# Review of the Design Changes Made for Xayaburi Hydropower Project

Technical Reference Paper  
No. 65

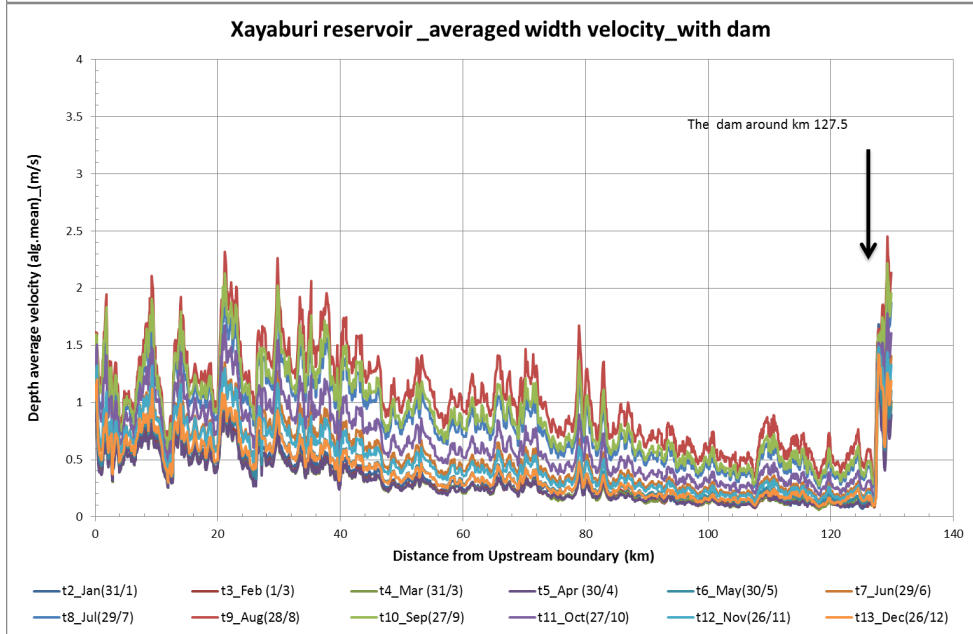
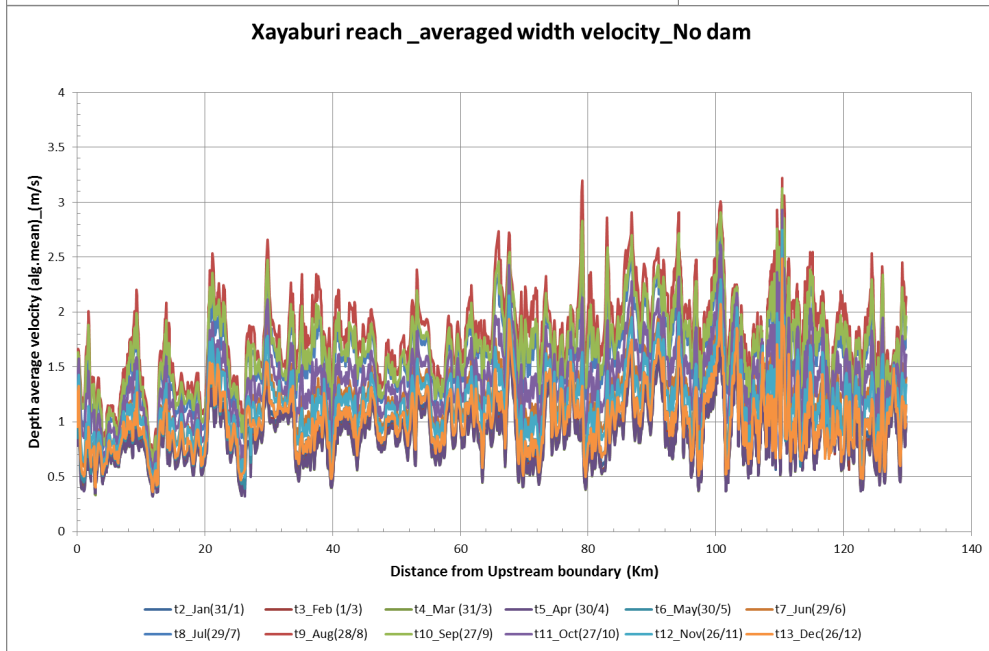
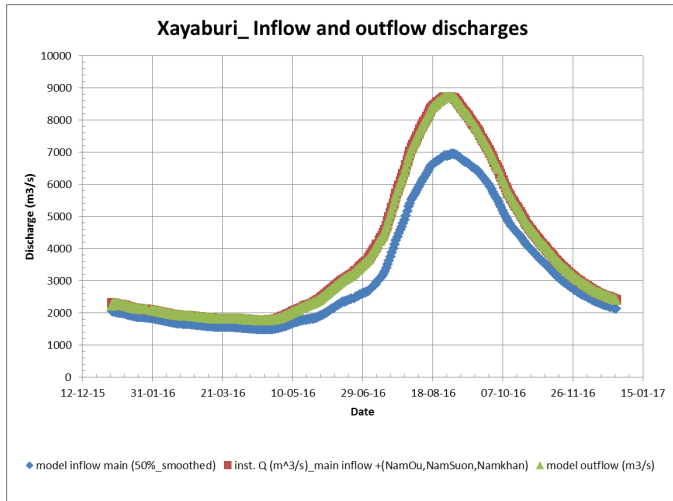
The Xayaburi TRR recommendation to use the navigation lock for fish passage was adopted. The redesign of the navigation lock has been outlined, however, further details such as attraction flow and cycle times would aid evaluation, as would information on the crowding mechanism in relation to the capacity to move fish in the system. The frequency and timing of the use of the lock for passage requires in-depth evaluation, as does the mechanism for use of the tandem lock system.

**Figure A4.1.** Drawing of Low level outlet (LLO) included in the re-design of the Xayaburi HPP. Top shows closed position, bottom shows LLO open, including operation of the flap gate. (GOL, 2011)

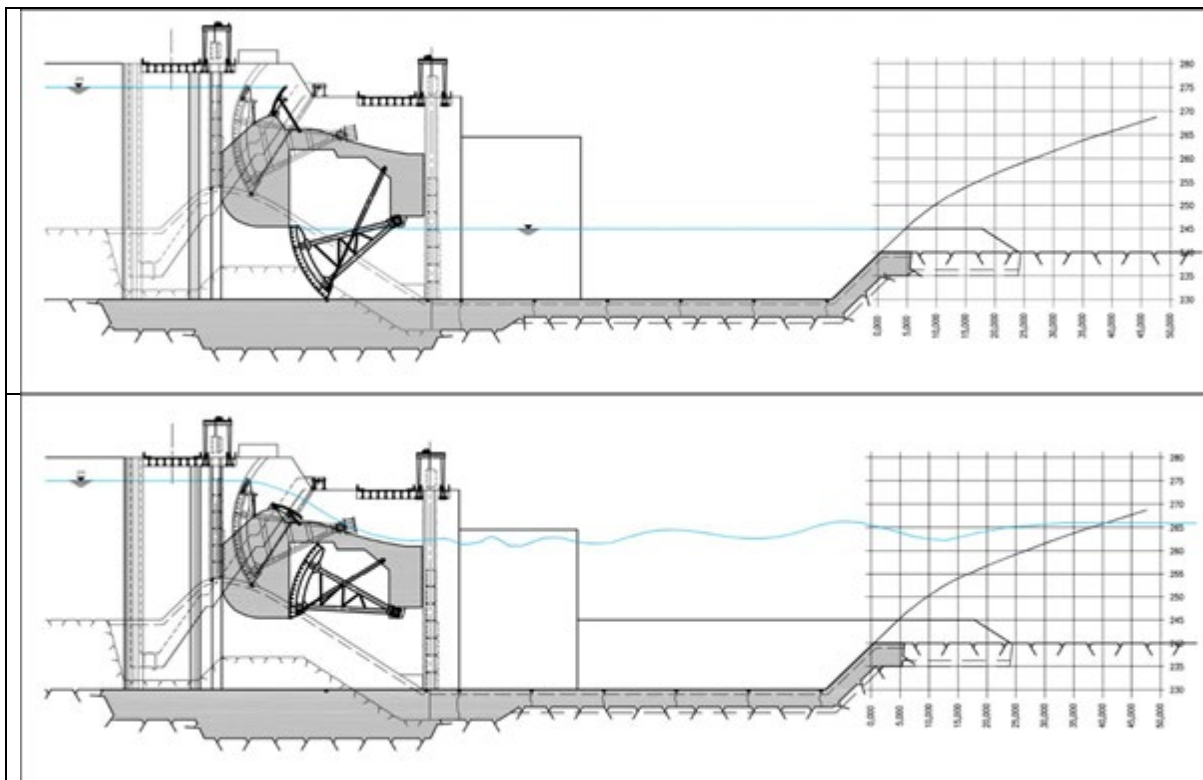
- Three spillway gates have been removed and replaced with 4 low level outlets (LLO) each with the dimension of 12 m x 16 m with a sill level of 238 m (Figure 5 & 6). The low-level gates include a flap gate to allow surface discharge as well as low level flow when the gate is open. These gates are intended to increase flexibility with respect to sediment management.
